# SERVICE BULLETIN

M-1408C

## 2014-2015 TOURING SADDLEBAG MOUNT - SAFETY RECALL 0166

### Reason for Revision

**Figure 1. Saddlebag Stud Receptacles (shown inverted from installed position)**

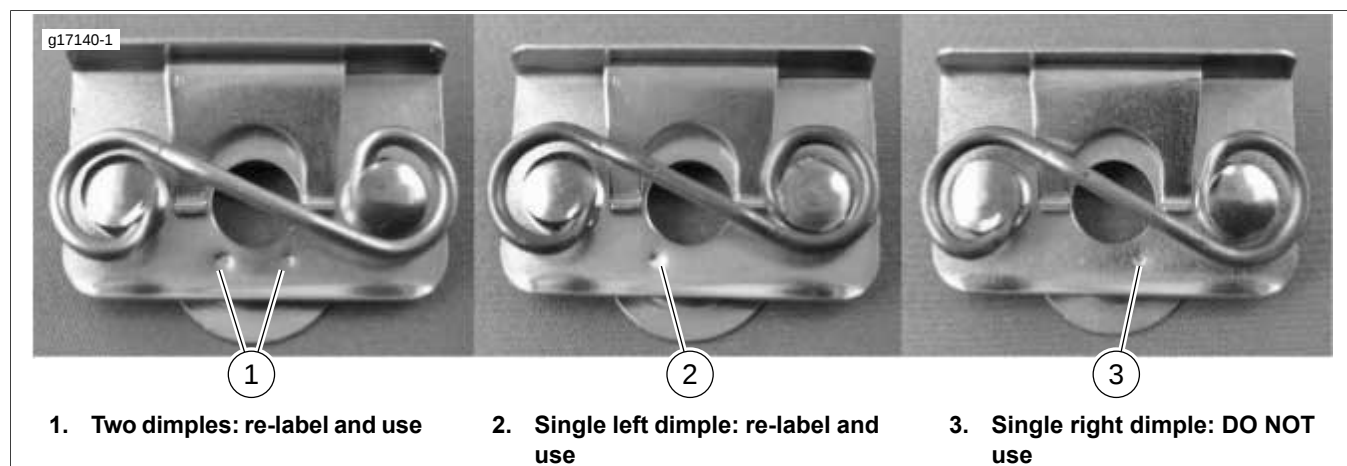
- Inspect all dealer inventory of kit 91500084.
  - If package has a date code of 07/14/15 or earlier, parts are good. Add an "A" after the part number.
  - See Figure 1. Inspect all later date code inventory of kit 91500084 as shown in the graphic.
  - Add an "A" to all kits that pass inspection.
- For kits that fail inspection, see 91500084 KIT RETURN PROCESS.

2. If recall kit package has date of 7/15/2015 or later than please sort per the attached photos, facing the spring side, clip opening down as shown.

Two Dots are good to use.  
Add "A" to the Part No.  
Kit is ready for use.

Left Dot is good to use.  
Add "A" to the Part No.  
Kit is ready for use.

Right Dot only **DO NOT USE.**

**Figure 2. Saddlebag Stud Receptacles**

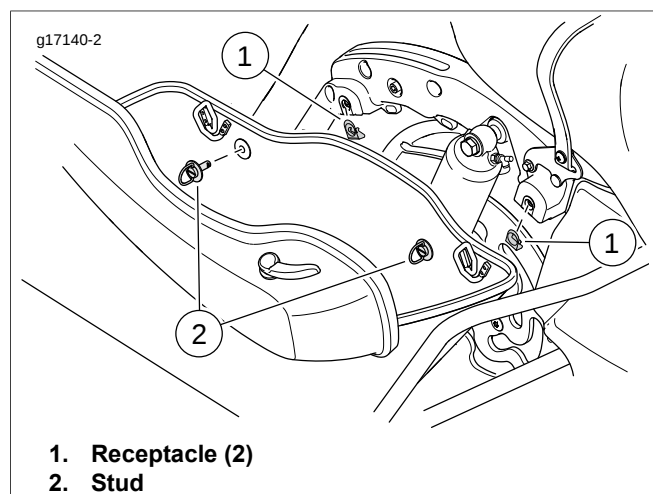
- Verify that the motorcycle is involved in this recall.
- See Figure 2. Remove saddlebags.
- Remove receptacles (1).
  - Insert a small screwdriver between receptacle clip and edge of saddlebag support.
  - Pry receptacle from saddlebag support.
- Install **new** receptacles supplied in kit.
- Install saddlebags using original studs (2) and washers.
- Confirm that stud has been rotated a **full 90 degrees** to ensure complete engagement.
